MODIFICATION SUMMARY

541

541 MODIFICATION SUMMARY

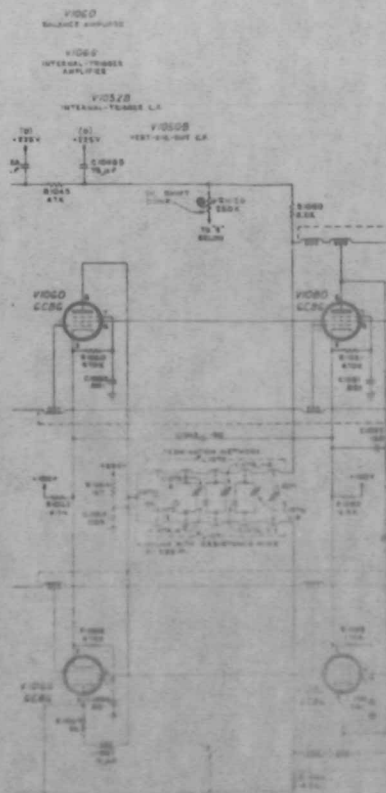
DESCRIPTION:

Reducing the value of C1074 and adding a new capacitor C1078 in parallel with C1076 extended the adjustment range of C1075 and C1076. They are located on the Vertical Amplifier termination network.

NOTE: C1075 is normally adjusted at minimum capacity; C1076 is normally adjusted at maximum capacity.

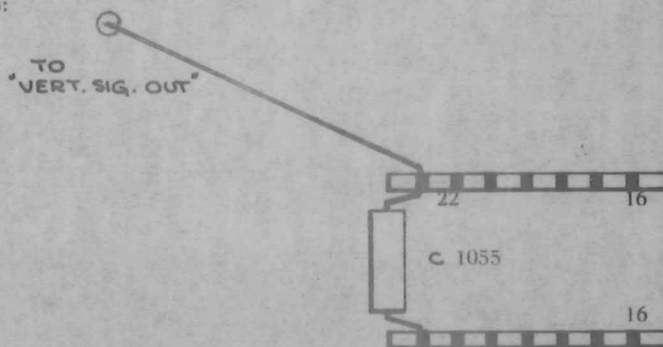
C1055 0.022 μ F 400V 285-515

C1055 0.022 μ F 600V 285-517

Replace C1055, a 0.022 μ F 400V capacitor on the Driver chassis, with a 0.022 μ F 600V capacitor.

M1413
(con'd)

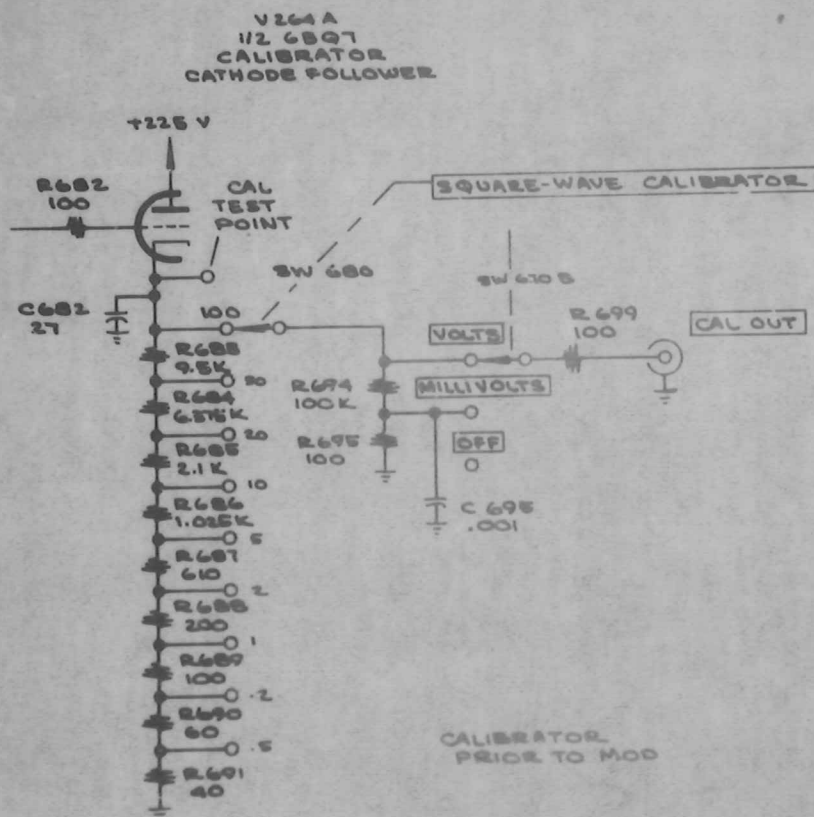
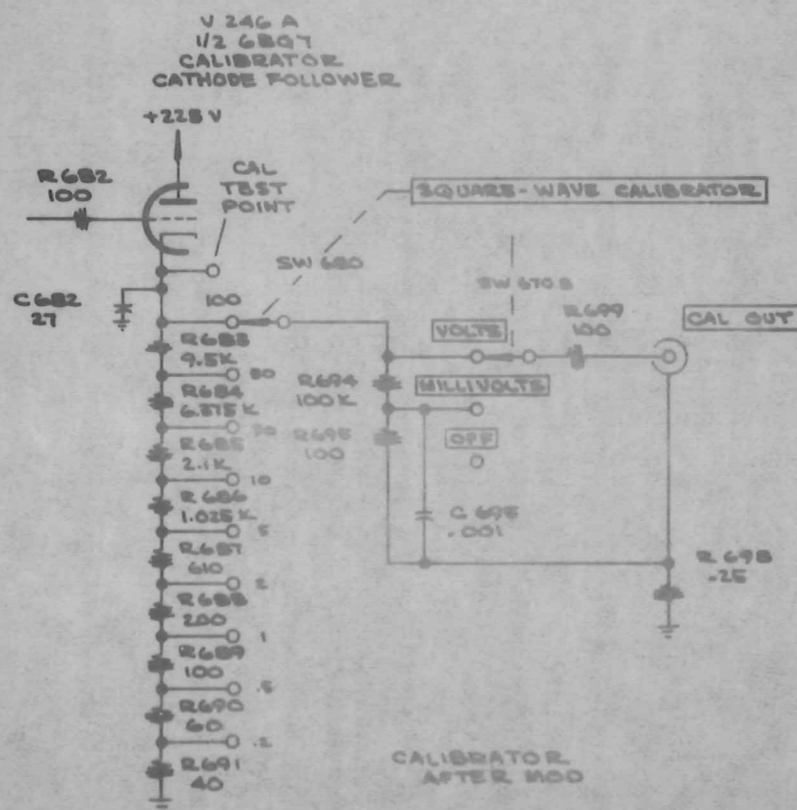
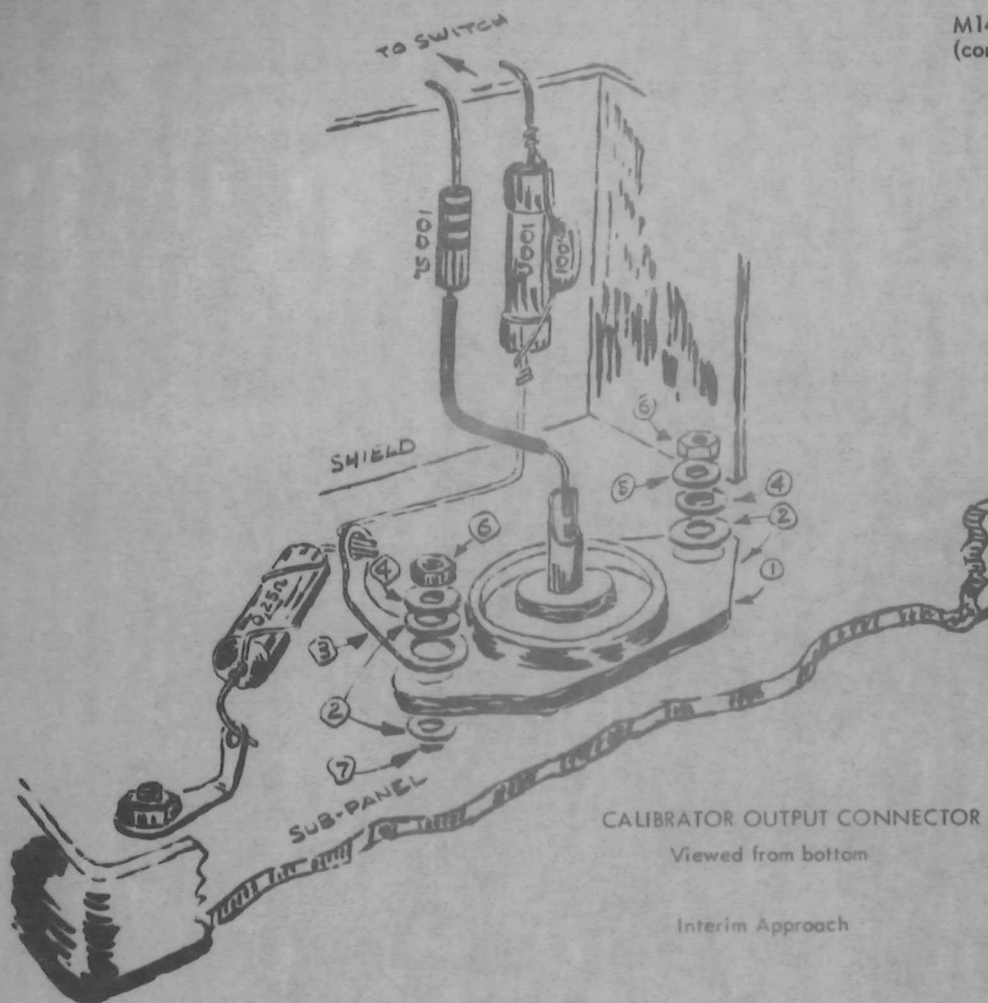
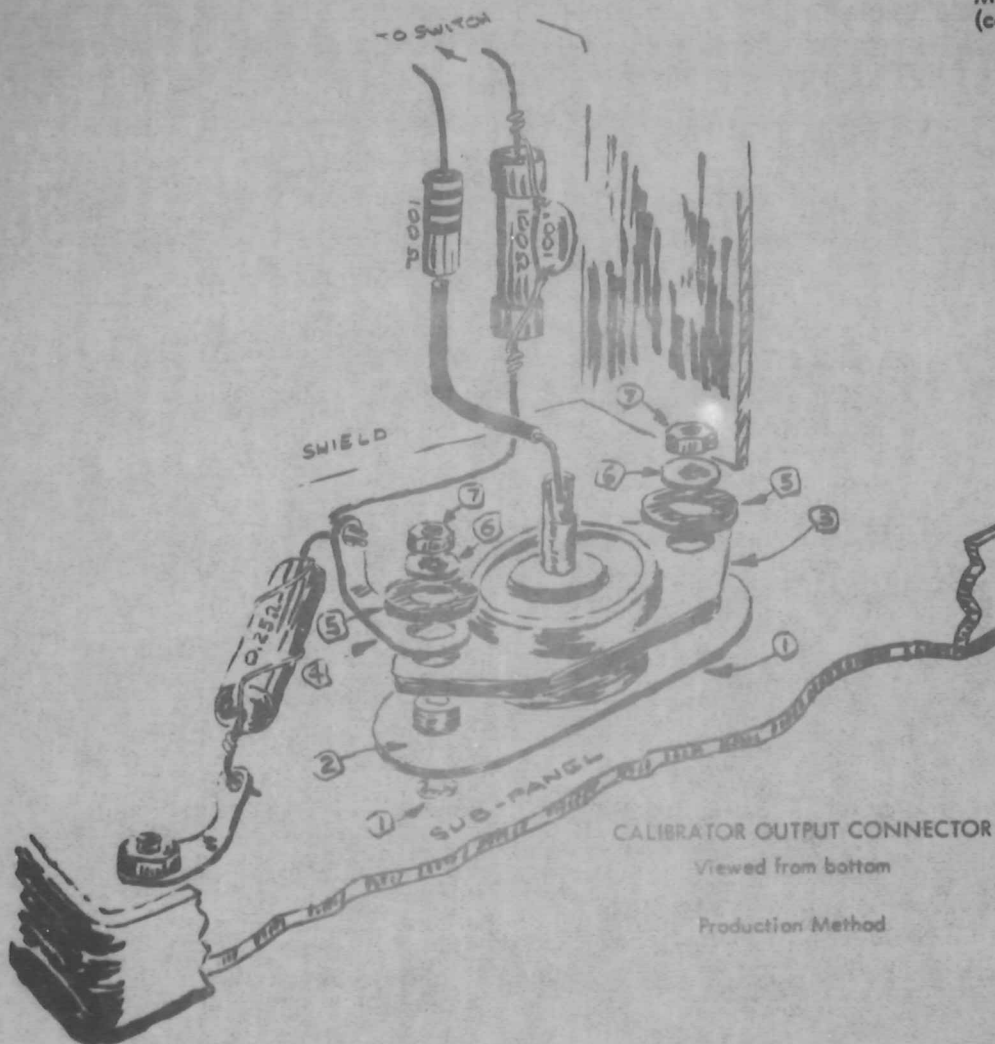
The mechanical changes necessary to the cabinet were included in the cabinet change, M1324, and involved the following:

R698	1/4 Ω 1/2w WW	308-090
Connector, modified		131-064
Lockwasher, int no.4		210-004
Lug, solder, no.10		210-224
Nut, hex, 4 x 3/16		210-406
Washer, plain, .55		210-801
Washer, fiber, extruded no.4		210-849
Screw, 4-40 x 3/8 FHS		211-025
Insulator, nylon		406-244

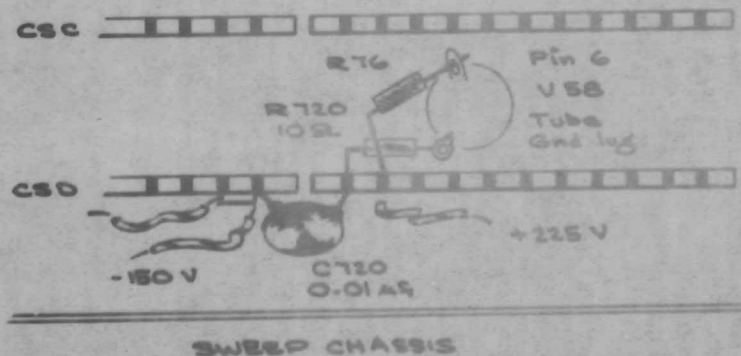
To reduce ringing and ripple in the -150V supply, a decoupling network was added between the -150V buss and ground. Although physically located on the sweep chassis, the C720-R720 combination will be shown in shunt with C715 on the LV Power Supply schematic.

- Relocate one end of R76, a 47 Ω 1/2w resistor, and the +225v lead from CSD-12 to CSD-13.
- Unsolder and discard the wire strap between CSD-12 and CSD-13.
- Install R720, a 10 Ω 1/2w resistor, between CSD-12 and the ground lug directly below it on the tube socket of V58.
- Install C720, a 0.01 μ f discap capacitor, between CSD-11 (-150v) and CSD-12.

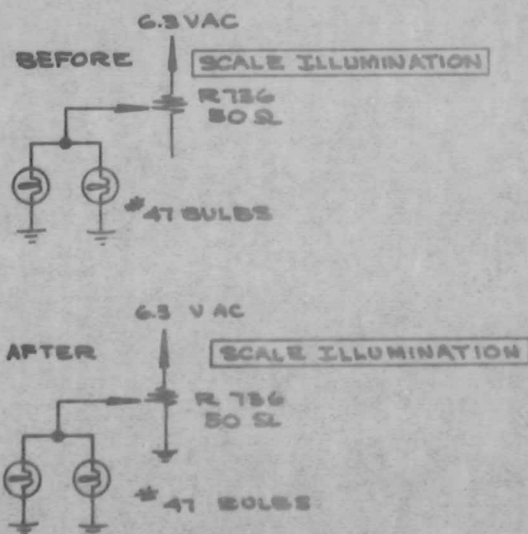
- Remove R736 (Scale Illum pot) and install lockwasher and solder lug between pot and subpanel.
- Solder unused terminal of R736 to the solder lug just installed.
- Interchange the two existing wires connected to the pot (the white-red-blue wire should now be connected to the outside terminal -- this places the pot between 6.3 v and ground.)

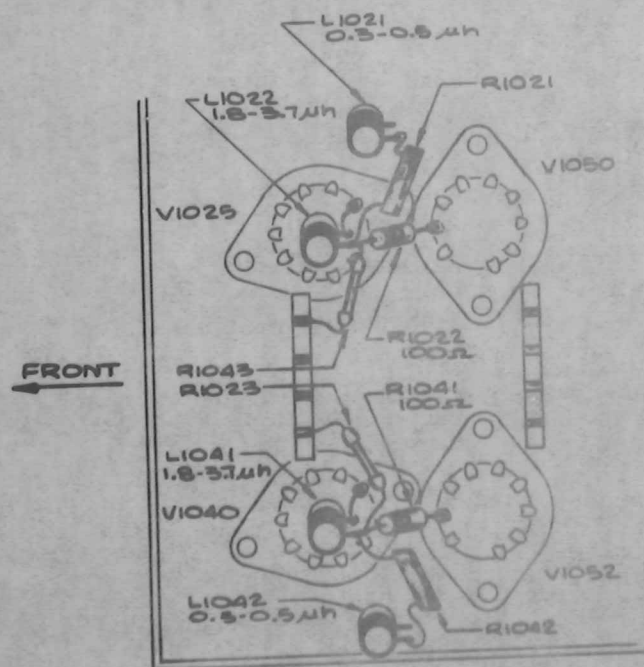
To accommodate the normal variation of transient response in the leading edge of a square wave, because of deviation in the gain of the input amplifier (V1025B and V1040B) and circuit variables, the fixed 2.5 μ H peaking coils, L1022 and L1041, are replaced by slug tuned 1.8-3.7 μ H coils mounted on the socket center of V1025 and V1040.

- a) Remove L1022 and L1041 (108-103).
- b) Replace L1021 and L1042 (0.79 - 1.5 μ H) with two 0.3-0.5 μ H coils.
- c) Install L1022 and L1041, Var, 1.8 - 3.7 μ H coils, on the bottom of tube sockets V1040 and V1025. Use two nylon 4-40 x 1/2 BH screws.
- d) Relocate R1023 and R1043, 68k 1/10W resistors from pins 9 of V1040 and V1025 respectively to the top terminal of L1041 and L1022.
- e) Connect the bottom of L1022 and L1041 to pins 9 of V1025 and V1040 respectively.
- f) Relocate R1021 and R1042 from pins 2 of V1050 and V1052 to the top terminal of L1022 and L1041.
- g) Install R1022 and R1041 between pins 2 of V1050 and V1052 and the top terminal of L1022 and L1041.

BEFORE M1692

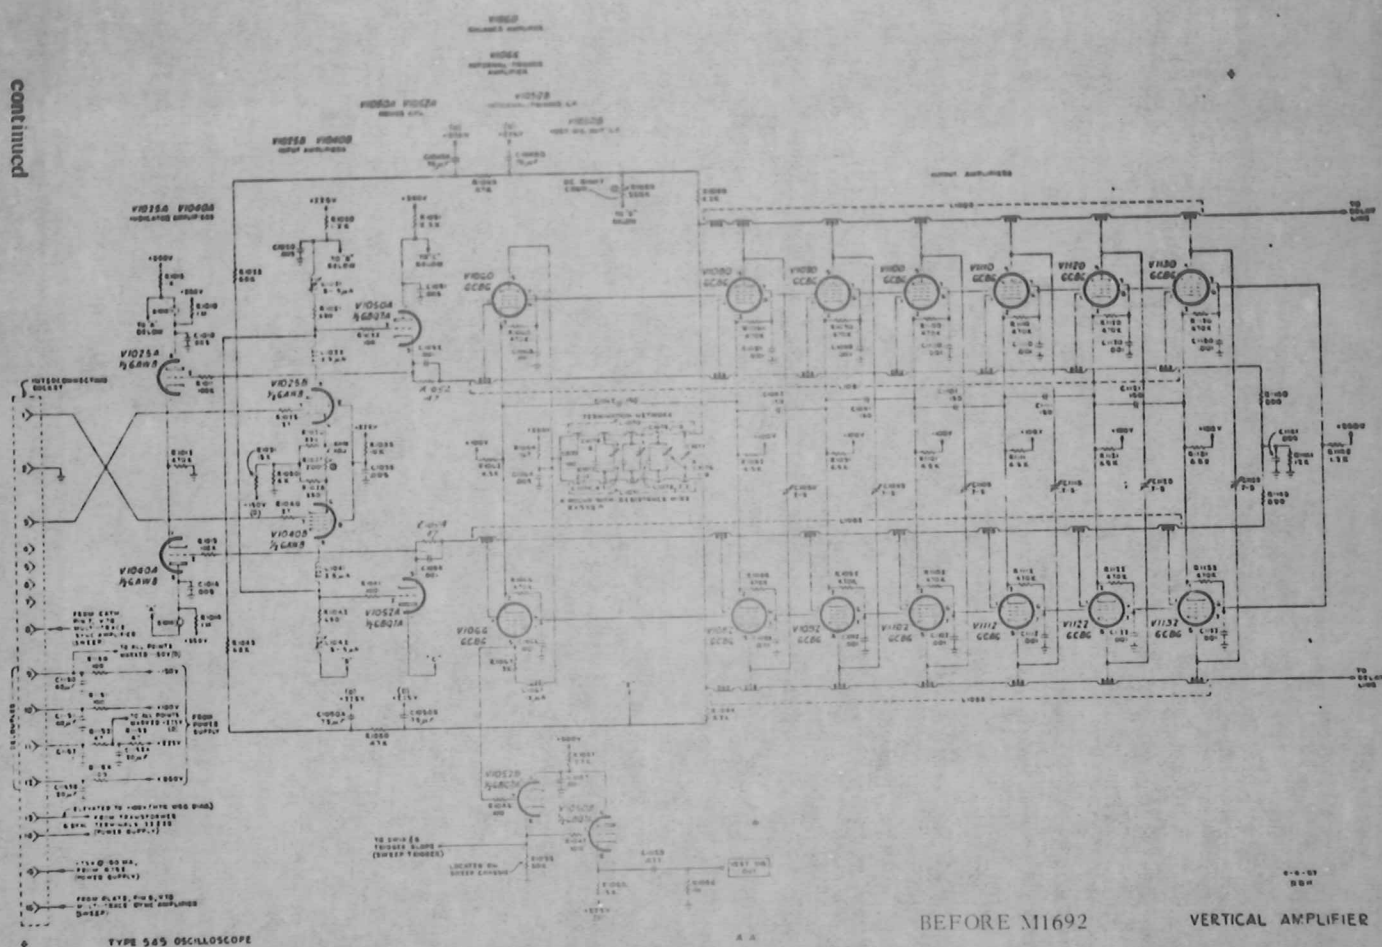
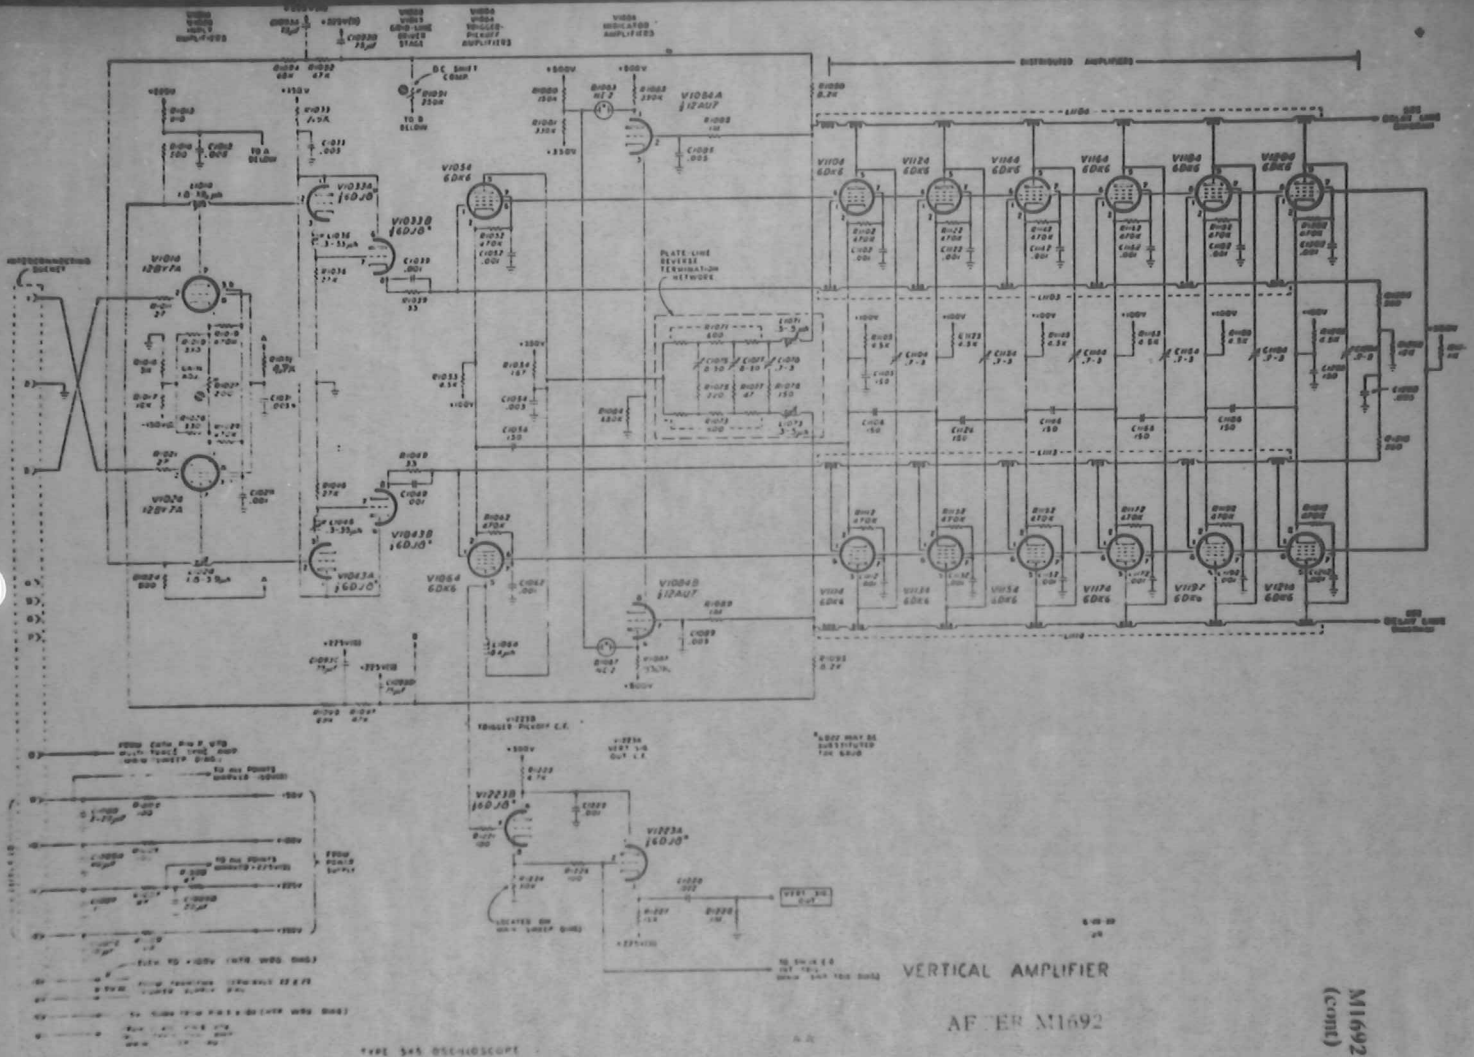
Connector, Amphenol	131-018
Cable, rectifier 530, 540	179-186
Termination Plate, Plexiglas	392-106
Chassis VA (RM45)	441-180
Socket, STM 7 (14)	136-008
Socket, STM 9 (6)	136-015

BEFORE M1708

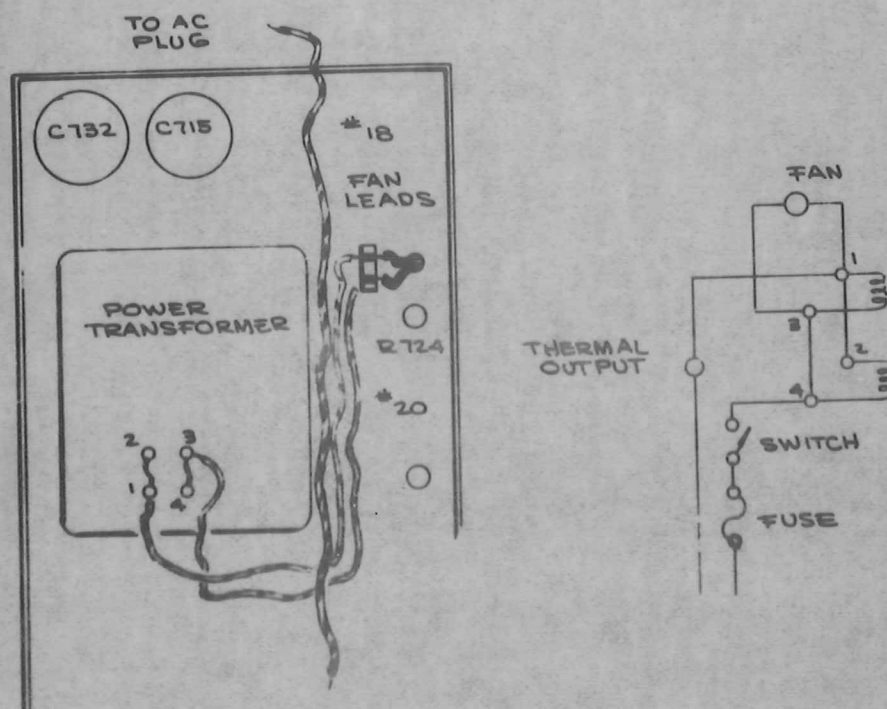
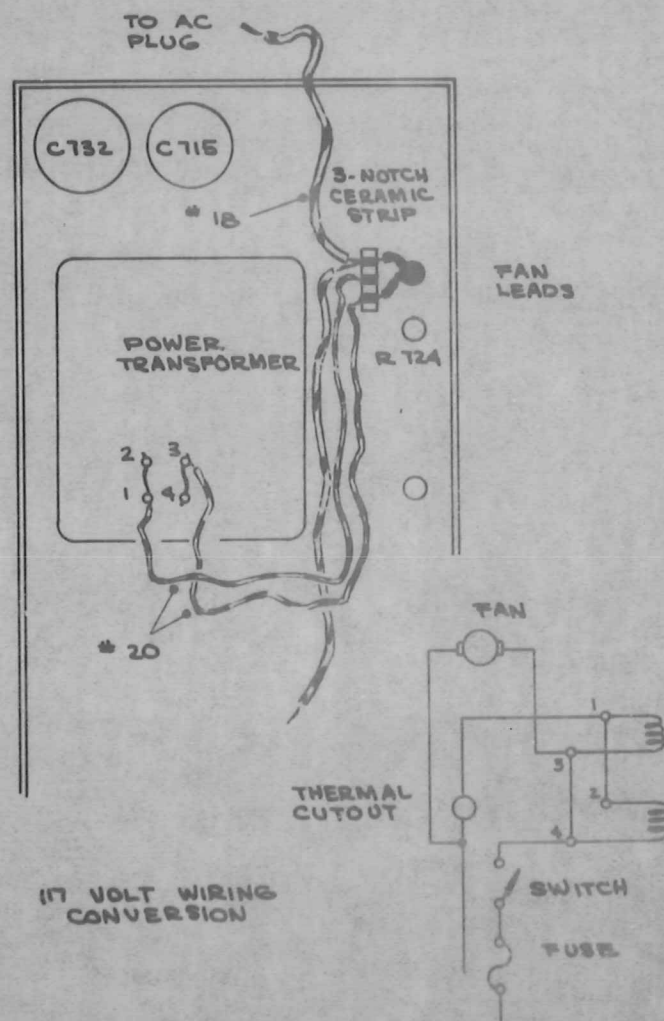
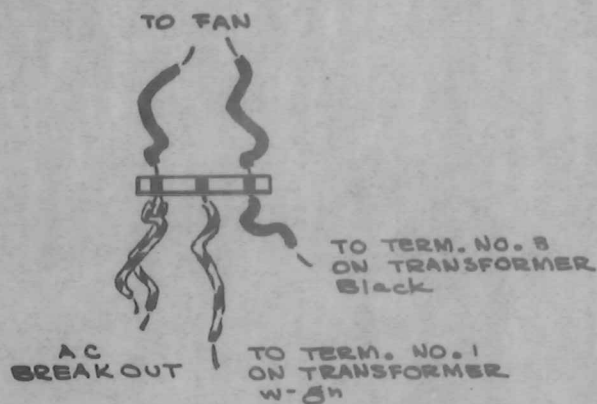
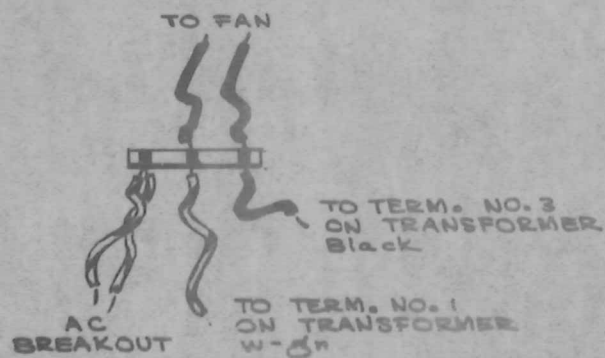
To enable the ventilating fan to continue operating after the thermal cutout has opened, the AC fan motor was connected ahead of the thermal cutout for 117 V operation. For the AC fan motor must continue to be connected across one of the power transformer primary windings behind the thermal cutout.

Instruments prior to s/n 6475 can be modified with a minor cable change and installation of a 3-notch ceramic strip in place of the 2-notch strip used previously, as shown in the drawing.

Conversion of instruments after s/n 6475 from 117 V to 234 V operation, or from 234 V to 117 V operation, must be accompanied with a change of fan lead hookup to the ceramic strip.

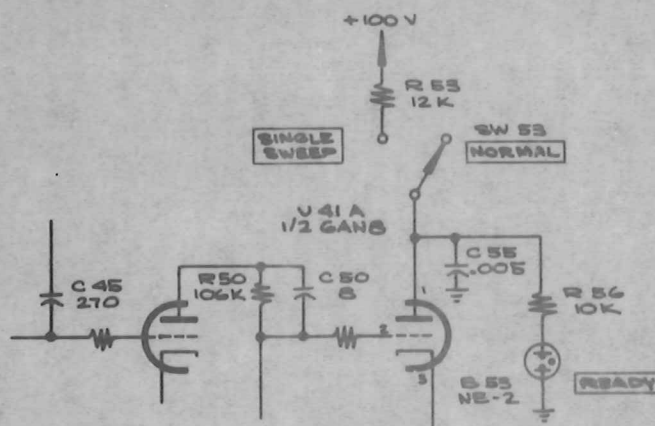
Decoupling was added to the Ready light and the multi circuit was changed to eliminated a spike, being generated by the Ready light, from preventing the circuit being locked out. Fourteen 531 instruments, along with about fifty early Sweep Lockout Field Modification Kits (040-118) could be effected by this problem.

R50	106k 1/2w 1%	309-161
C45	270 pf 500v	281-545
R56	10k 1/2w 10%	302-103
C55	0.005 pf 500v	283-001
